SERVICE LETTER

No. 667A

Piper Aircraft Corporation

Stabilator Attachment Bolts

Stabilator Attachment Hardware

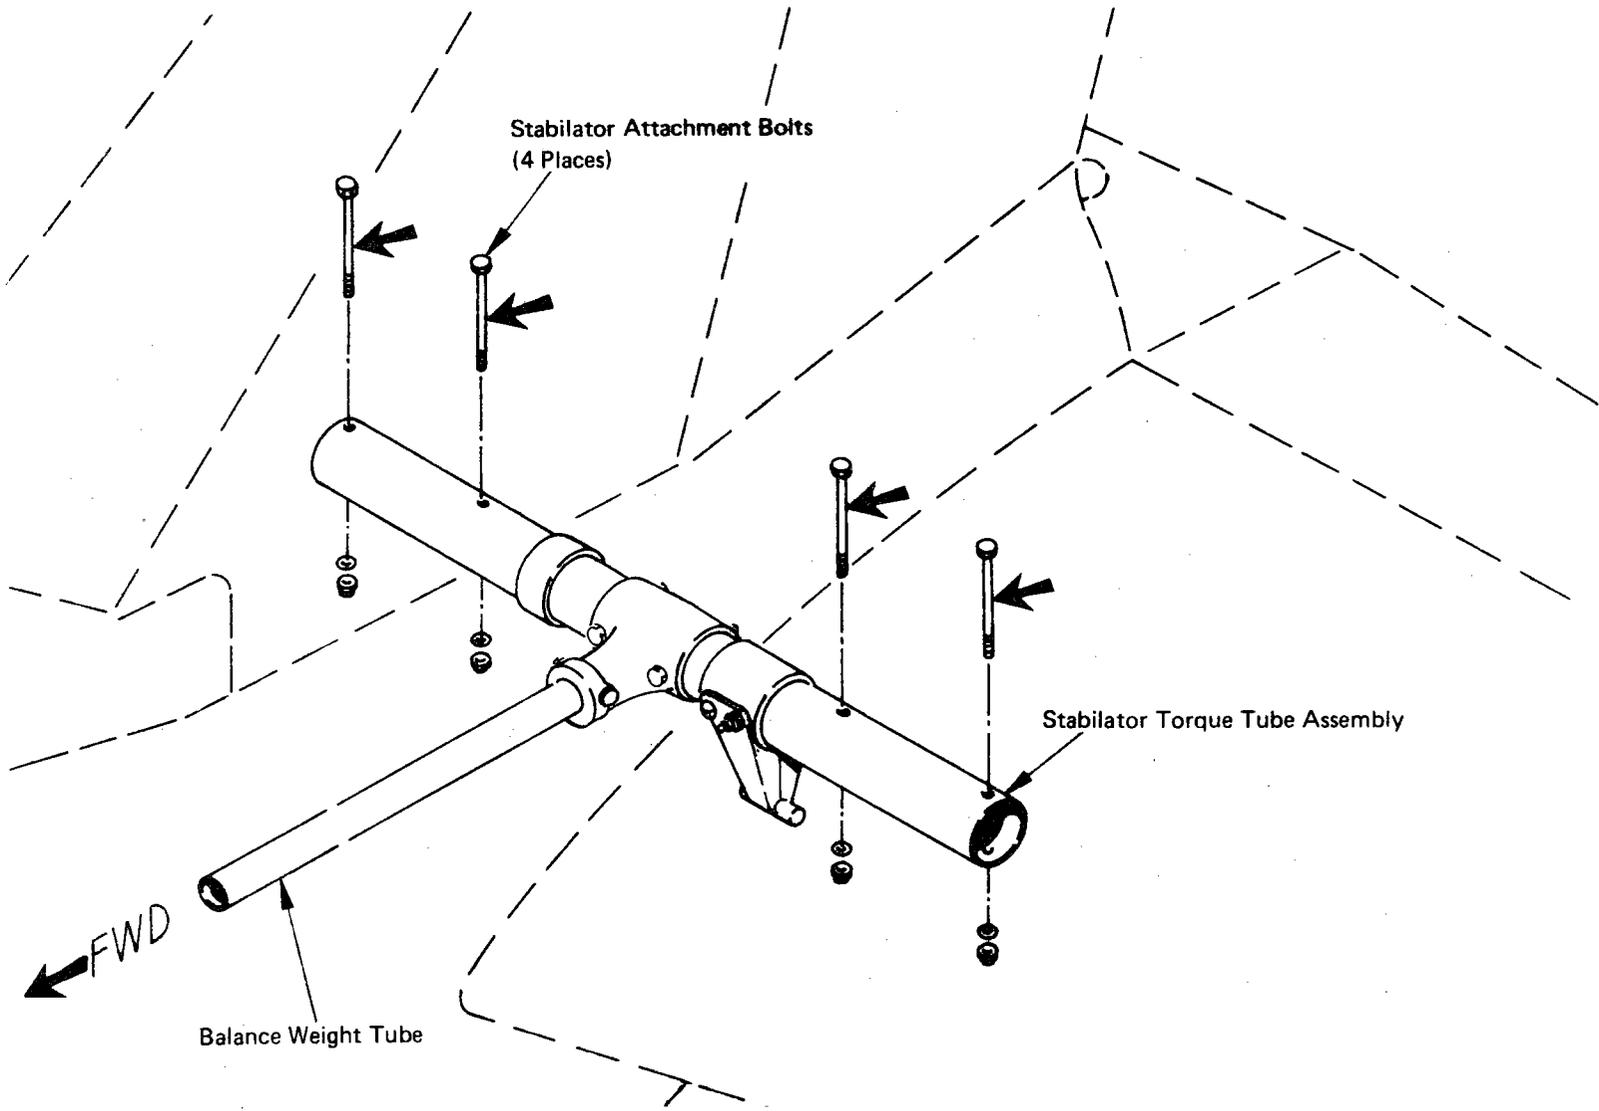
Remove existing stabilator attachment bolts, washers and nuts, indicated on sketch, and install new bolts and attaching hardware.
CAUTION: Remove and replace one bolt at a time. Refer to sketch for correct replacement hardware identification and proper assembly of bolts, washers and nuts.

2. Correct torque value for bolts is as follows:
 - a. PA-24-180/250 and 260 - torque to 30-40 inch lbs.
 - b. PA-23-235/250/250 (Six Place) and PA-24-400 - torque to 60-85 inch lbs.
 - c. PA-30 - Refer to the Twin Comanche Service Manual (Section 4 - paragraph 49) which states that the nuts ("holding the stabilator to the torque tube") should "be tightened just enough to take the play out of the washers."

Bolt AN174-C32A P/N 502 329 (Corrosion Resistant) or Bolt AN174-32A P/N 402 329 (Non-Corrosion Resistant)
 Washer AN960-416L P/N 407 585
 Nut MS20365-428C P/N 404 888

Bolt AN175-C32A P/N 502 342 (Corrosion Resistant) or Bolt AN175-32A P/N 402 342 (Non-Corrosion Resistant)
 Washer AN960-516 P/N 407 566 (PA-23-235/250 and 250 Six Place only)
 Washer AN960-516L P/N 407 586 (PA-24-400 and PA-30 only)
 Nut MS20365-524C P/N 404 889
